# Product Change Notification

**Change Notification #:** 116158 - 01  
**Change Title:** Intel® Server Chassis H2204XXLRE,  
Intel® Server Chassis H2216XXLR2,  
Intel® Server Chassis H2224XXLR2,  
Intel® Server Chassis H2224XXLR3,  
Intel® Server Chassis H2312XXLR2,  
Intel® Server Chassis H2312XXLR3,  
Intel® Server Power Supply  
FXX2130PCRPS,  
PCN 116158-01, Product Design, Label,  
Power supply 2130W firmware and label  
update,  
Reason for Revision: Update the TA of  
H2204XXLRE, add products affected, and  
update the firmware revision  
**Date of Publication:** June 18, 2019

**Reason for Revision: Update the TA of H2204XXLRE, add products affected, and update the firmware revision**

Image 1. PSU label before change

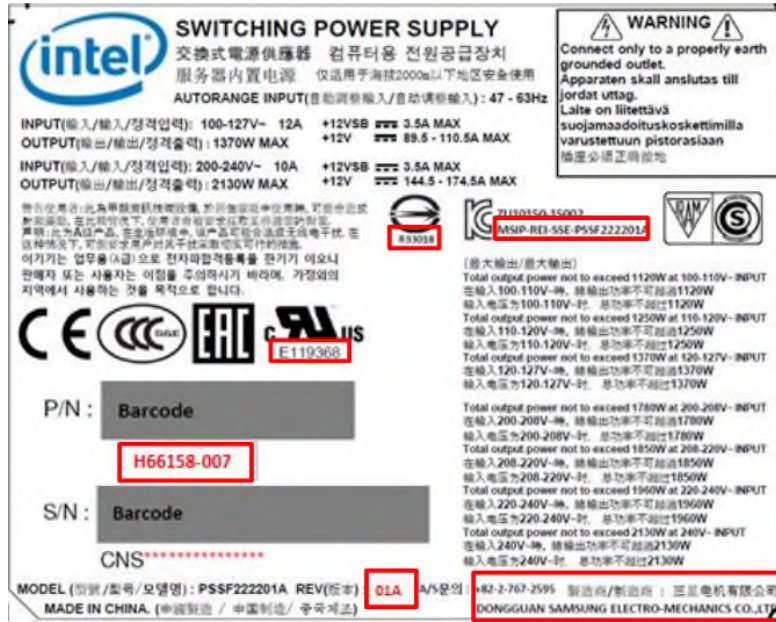
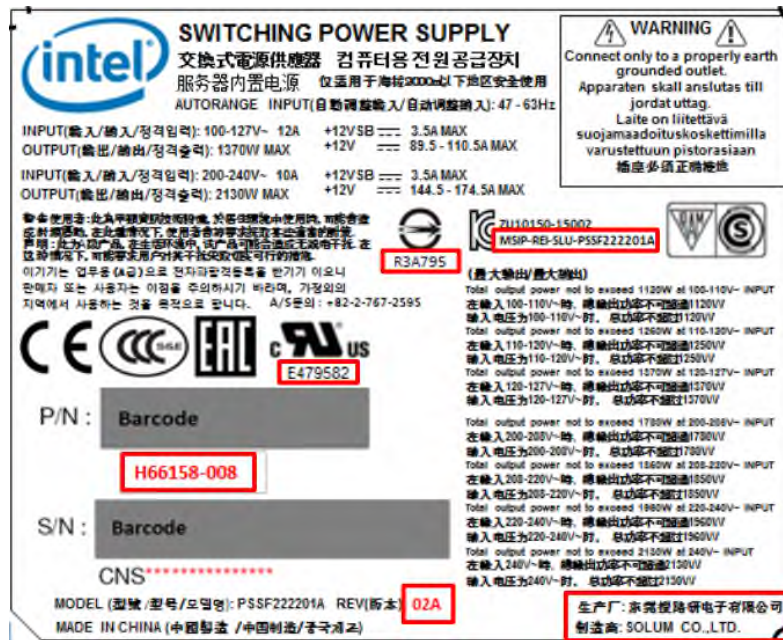
Intel is implementing the following changes on the label of Intel® Server Power Supply FXX2130PCRPS. The change updates the Top Assembly number (TA) of Intel® Server Chassis listed in the table “Products Affected”.

1. Change the manufacturing site from SAMSUMG® to SoluM®
2. Replace the safety logo “CQC” to “CCC”
3. Update the number of the safety logos of BSMI, UL and KCC
4. The firmware of the Power Supply updates from 21.0.128 to 28.0.128 (MCU and FRU update).
  - a. Update the power supply product number from H66158-007 to H66158-008
  - b. Update the power supply revision number from 01A to 02A
